#### **ADDENDUM #4**

PROJECT : CODESTACK ACADEMY

REF. # : ARCH PROJ. No. 2023-04

DATE: 11 March 2025

S5.6

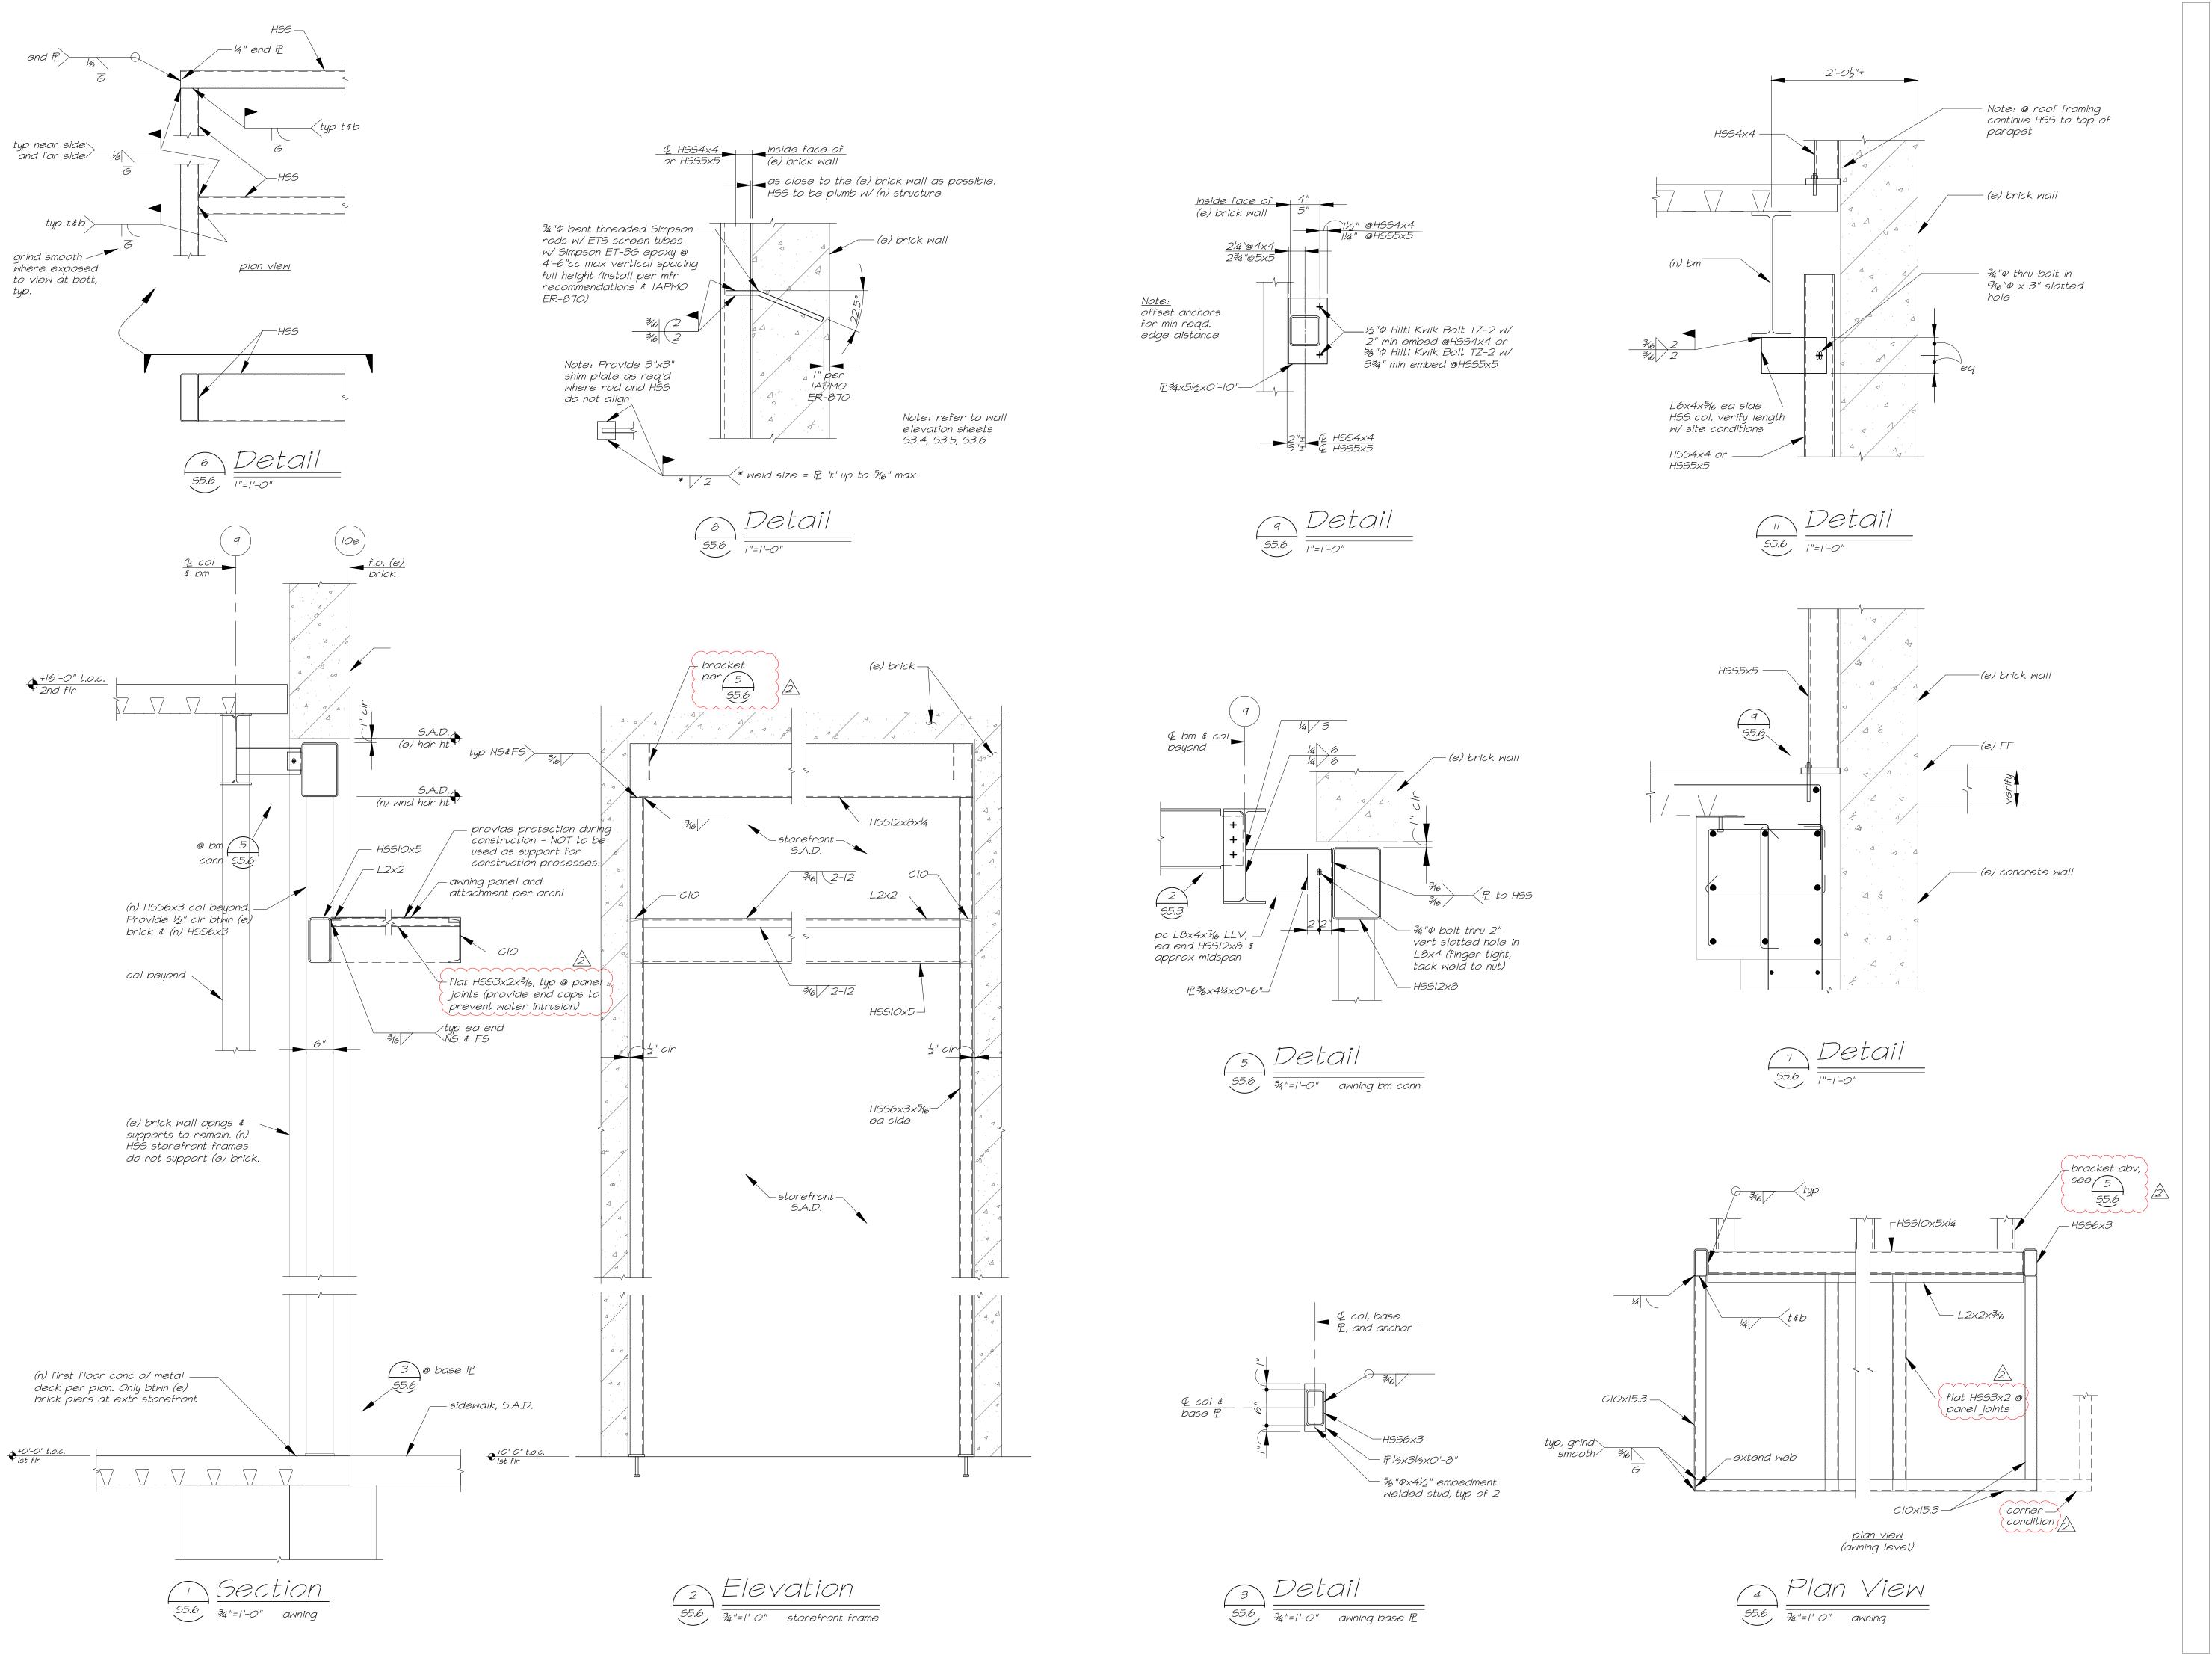
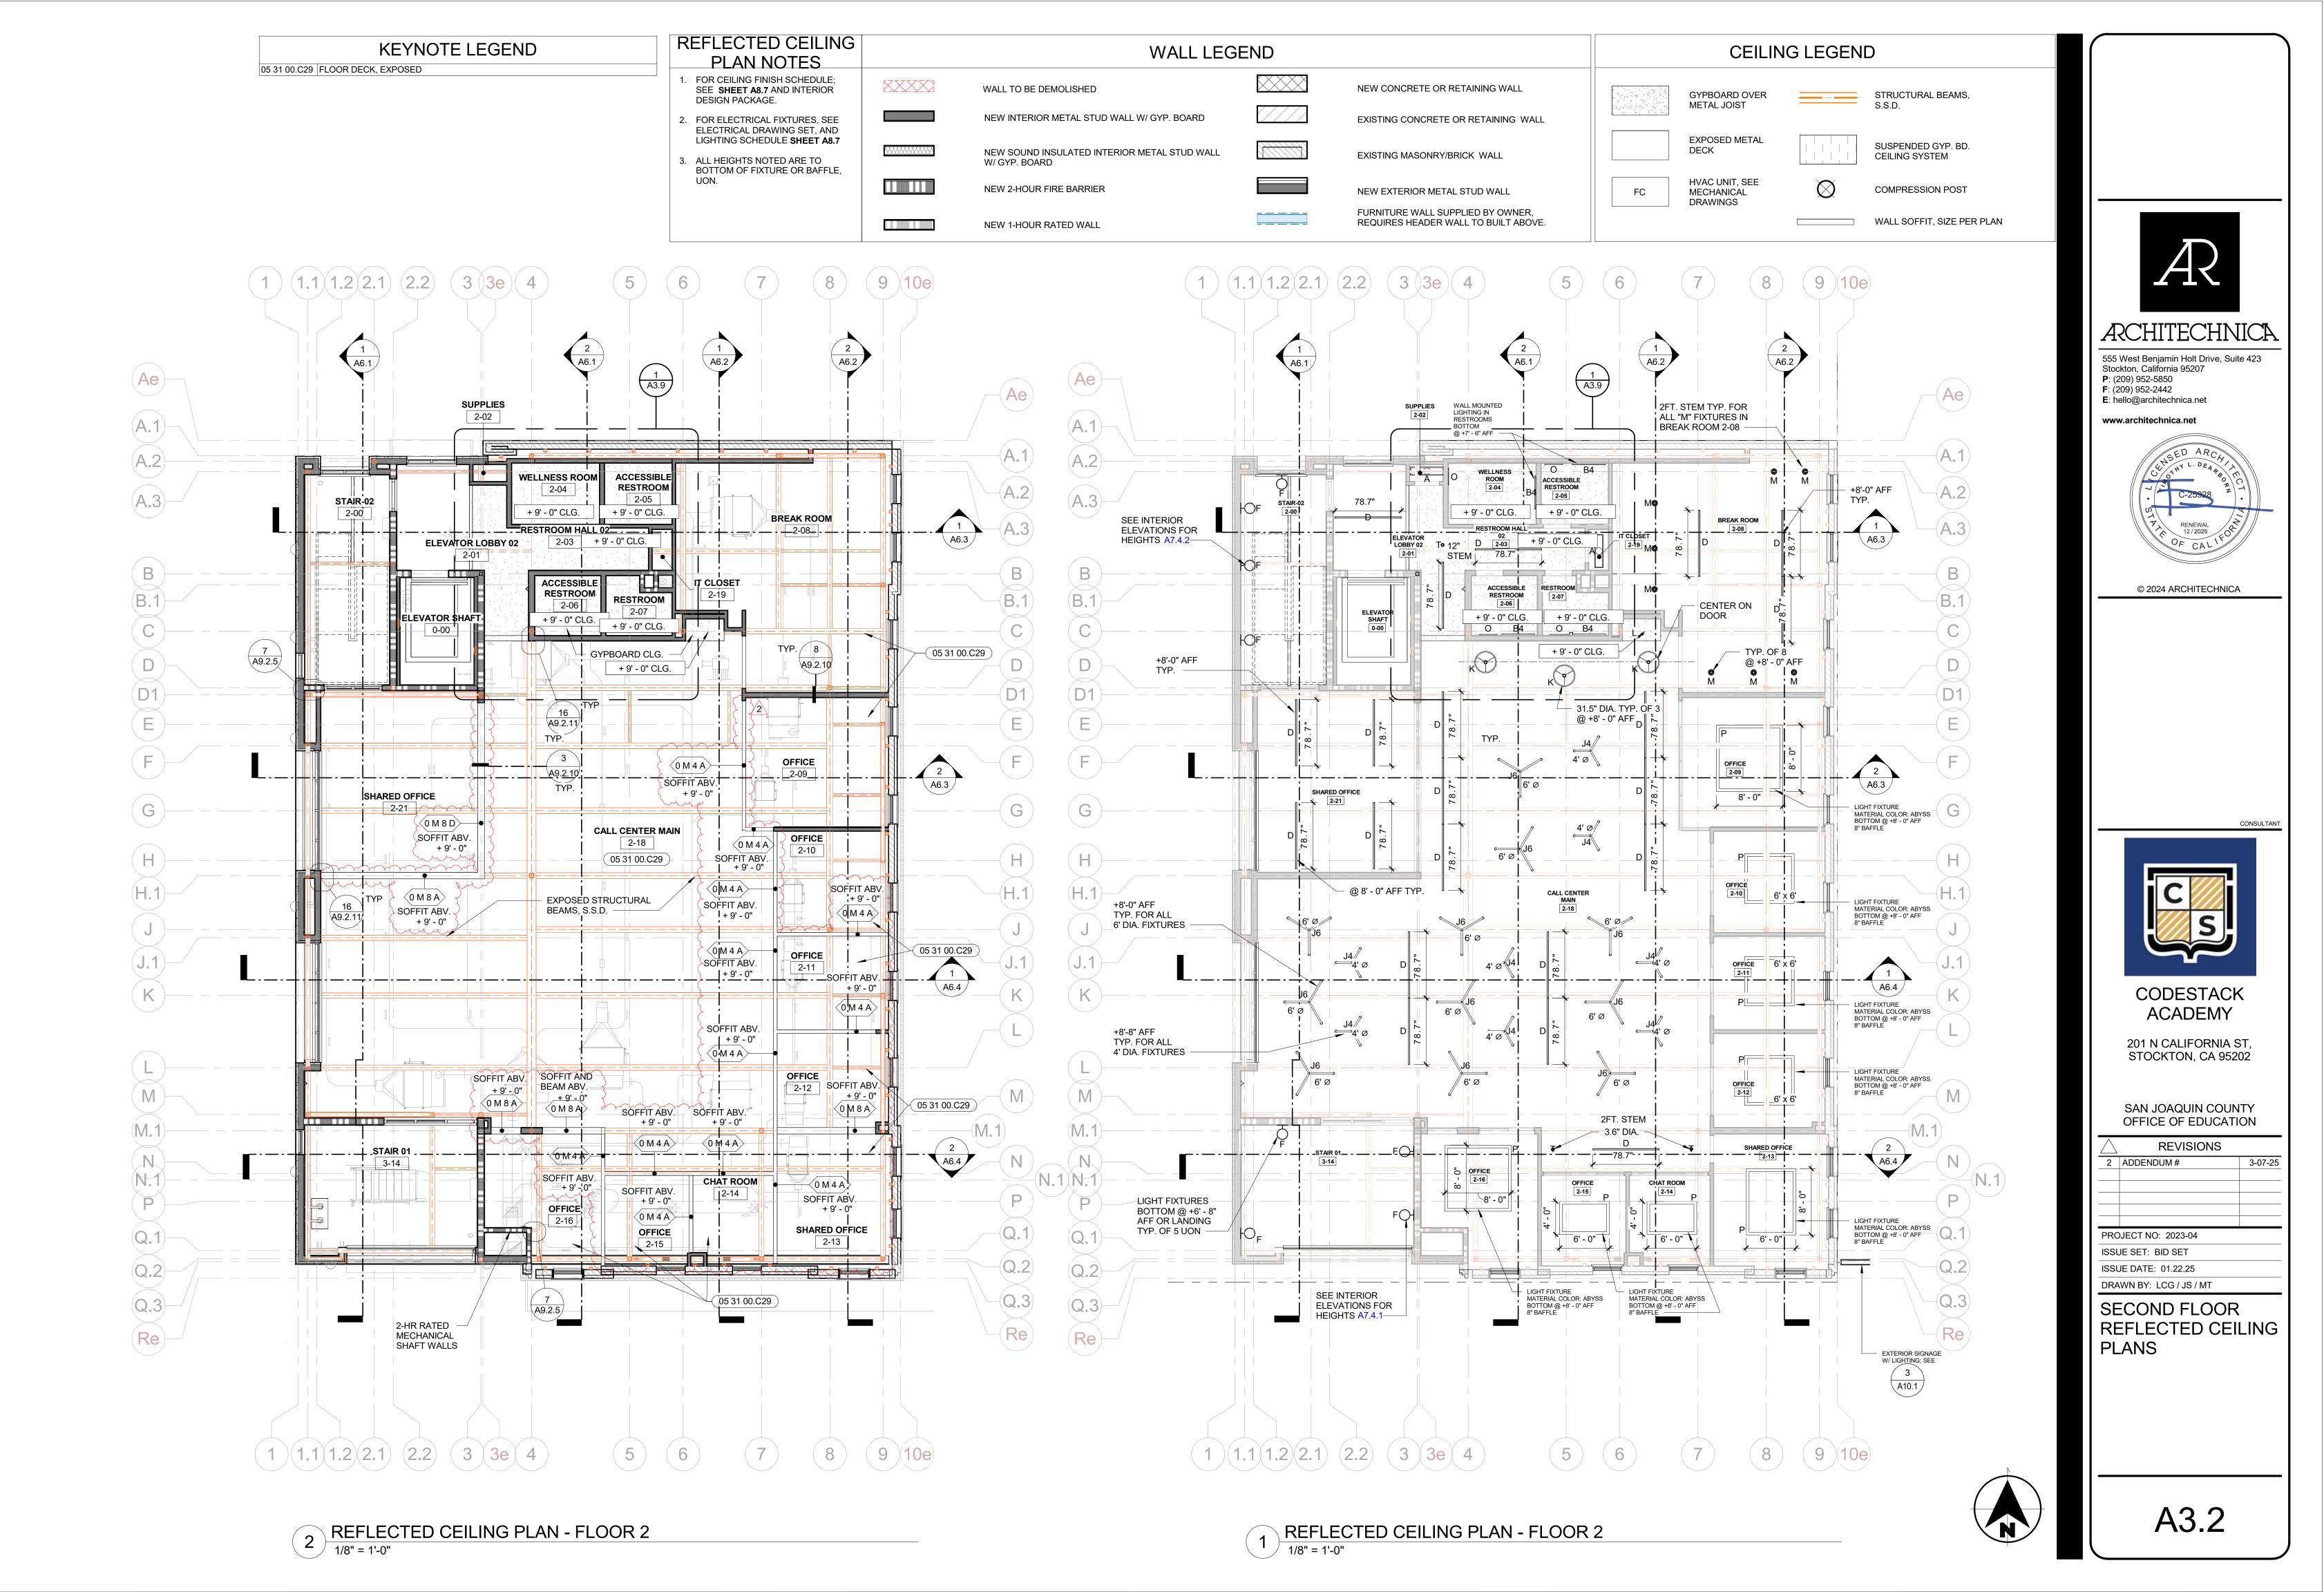
**ITEM 40 Drawing sheet:** S5.6 (attached)

**DESCRIPTION:** Add notes for awning details.
